Subject: Duke Energy Carolinas, LLC  
Oconee Nuclear Station, Units 1, 2, and 3  
Renewed Facility Operating License, DPR-38, DPR-47, and DPR-55  
Docket Numbers 50-269, 50-270, and 50-287  
Oconee External Flood, Response to Request for Additional Information (RAI)

## Attachment 1- RAI Responses

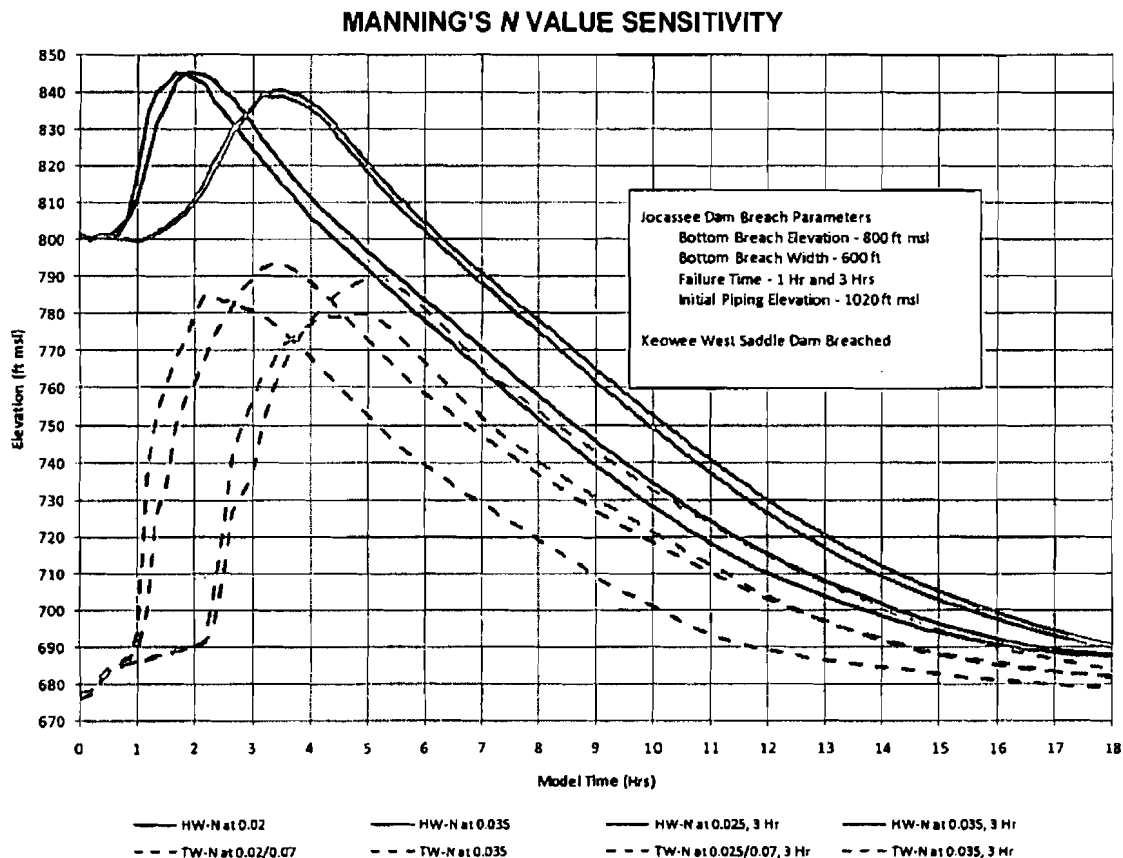
Justify the use of the different Manning  $n$  values for the following areas: Little River Basin below the channel, the Keowee River below the Jocassee tailrace, and in the Keowee tailrace extension to the road bridge. Specifically, describe how the  $n$  values selected represent a conservative value.

HEC-RAS model, a review of the sensitivity was conducted. The Manning's  $n$  value transitioned as shown below for the main channel for both the Jocassee tailrace (Lake Keowee) and the Keowee tailrace (Lake Hartwell).

The Figure below provides the relative stage hydrograph comparisons at Keowee Dam for Manning's  $n$  values of 0.02, 0.025, and 0.035. The headwater, or HW, shall be considered the water located upstream of the Keowee Dam. The tailwater, or TW, shall be considered the water located downstream of the Keowee Dam.

Manning's  $n$  value has a direct impact on the stage hydrograph timing of the headwater and tailwater events. Lower  $n$  values result in a stage hydrograph shifts so as to reduce time to peak water surface elevations for the tailwater area below Keowee Dam. The variation of  $n$  values had minimal impact on the headwater side of the Keowee Dam. The transitioning in  $n$  values also revealed under similar breach parameter conditions, the tailwater stage hydrograph peak elevations tend to increase with a Manning's  $n$  value of 0.035 than with the  $n$  value of 0.07 with transitioning to 0.02/0.025.

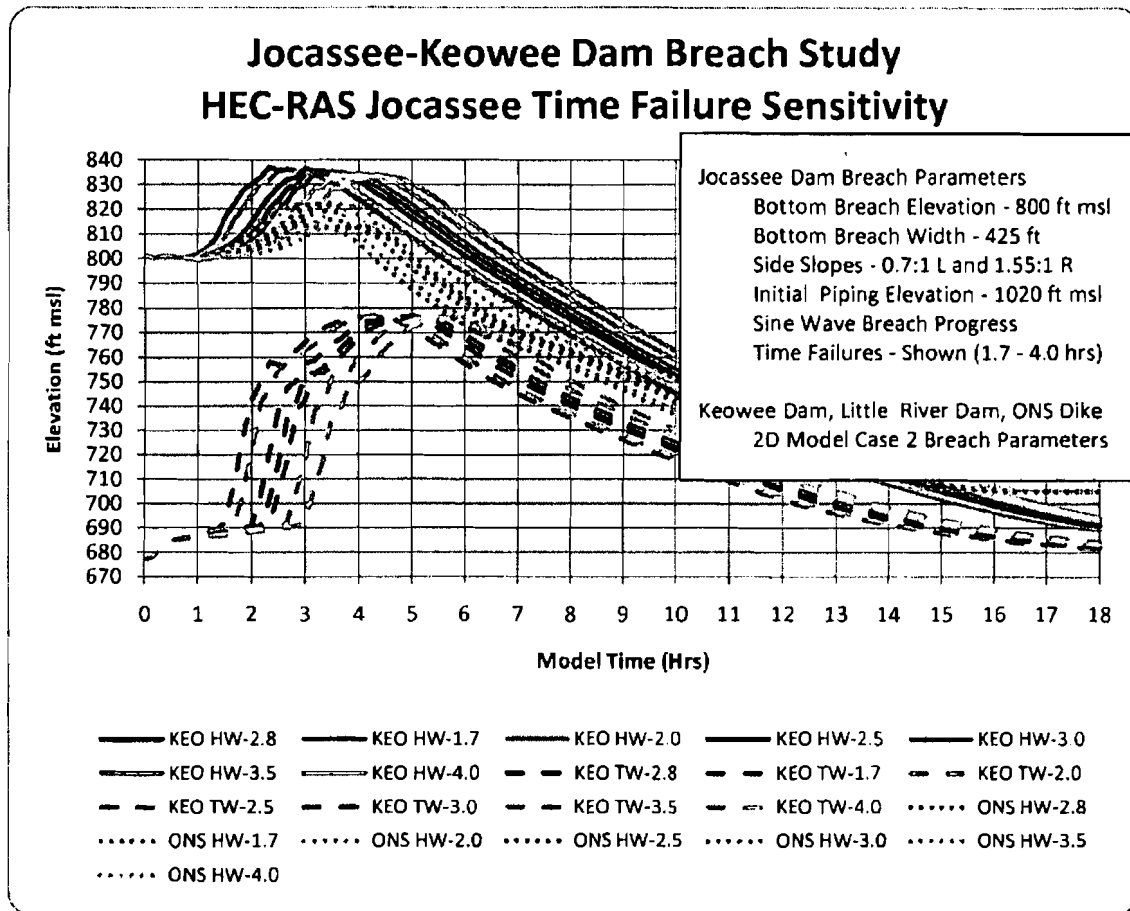
Provide the key for your runs associated with the sensitivity analysis for the Hydrologic Engineering Center – River Analysis System (HEC-RAS) model.

The target being monitored with this sensitivity analysis is the final water heights at and around the Oconee site. In order to do this evaluation, some parameters of the model will need individual sensitivity evaluations to determine their role in the overall outcome, or results. In other words, does or does not the individual parameter play a key role in determining the water height at Oconee. This can be done by varying the parameter and holding all other parameters constant.

The model also has many contributing parameters feeding into one large model input for breach size. All these possible combinations essentially can yield very similar results, or outcomes that actually represent a single large parameter – the breach size. Therefore, if a group of parameters can be collectively represented by a single value, or input parameter, so that the representative outcome reflects the contribution of the individual parameters, then this will be done so as to simplify this assessment. In this case, one parameter reflects the summation of several 'detail' parameters.
